SYDNEY CENTRAL CITY PLANNING PANEL

COUNCIL ASSESSMENT REPORT

Panel Reference	PPSSCC-285
DA Number	DA/812/2021
LGA	City of Parramatta Council
Proposed Development	21-27 storey mixed-use building incorporating retail, commercial, boarding house and shop-top housing uses. Concept component of a staged application, seeking approval for building location, footprints and envelope; pedestrian links; pedestrian/vehicular entries; open space and landscaping. The development would be delivered across two stages requiring further development consent. 50% of the residential floor space would be affordable housing pursuant to State Environmental Planning Policy (Affordable Rental Housing) 2009. The application is to be determined by the Sydney Central City Planning Panel.
Street Address	33 – 43 Marion Street, Parramatta NSW 2150 (Lots 10-13 Sec 1 DP976, Lot 14 DP182289, Lot A DP349279, Lot 1 DP747666)
Applicant	Pacific Planning Pty Ltd
Owner	Loura Petroleum Pty Ltd, CN Marion Pty Ltd, 2 x individuals (not named for privacy reasons)

Summary of key submission	<ul style="list-style-type: none"> • Overshadowing • Loss of Ventilation / Breeze • Excessive Height
Report prepared by	Alex McDougall E

Figure 10. Concept scheme axiomatic view from the north-east with non-compliances shown in pink (diagram does not show non-compliance with northern podium setback).

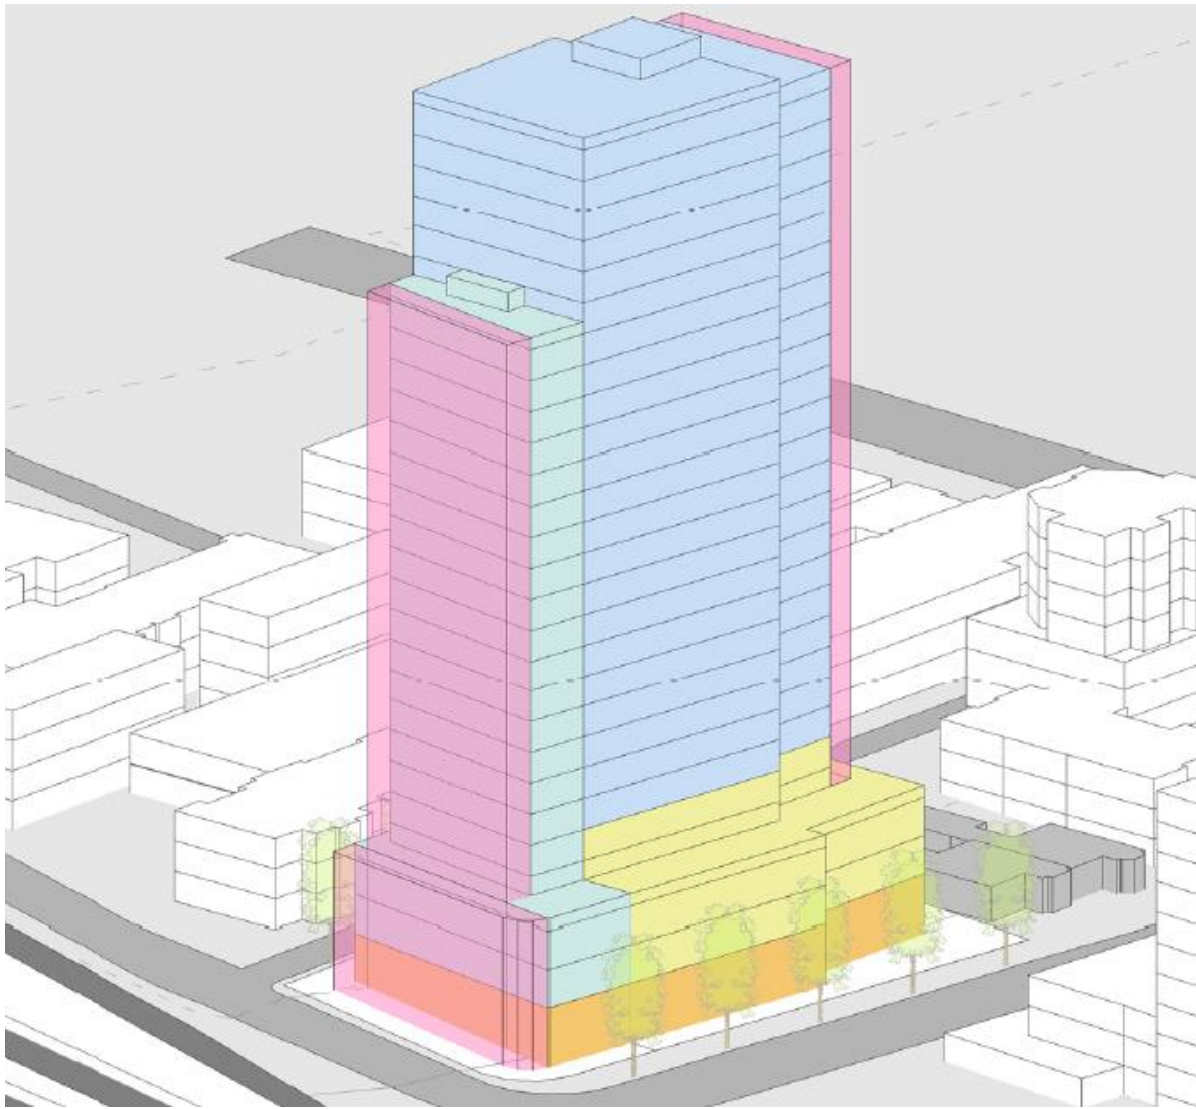
The proposal is non-compliant with several site-specific envelope controls, as outlined in the table above and figure below. The non-compliances are the result of attempting to include significant floor space bonuses and stage the development.

The non-compliances with the tower envelope controls result in additional amenity impacts on the dwellings to the south.

The non-compliance with the northern podium setback could potentially have heritage impacts (not justified through heritage statement as outlined elsewhere in this report).

The non-compliance with the eastern podium setback control would fail to achieve the objectives of the control, namely an improved pedestrian friendly environment and visual connections in Station Street West. The draft Parramatta City Centre DCP seeks to set up setbacks to Station Street West to account for a historic irregularity in the subdivision pattern (see Figure 11 below). Allowing a non-complying setback would thwart the wider planning for the street.
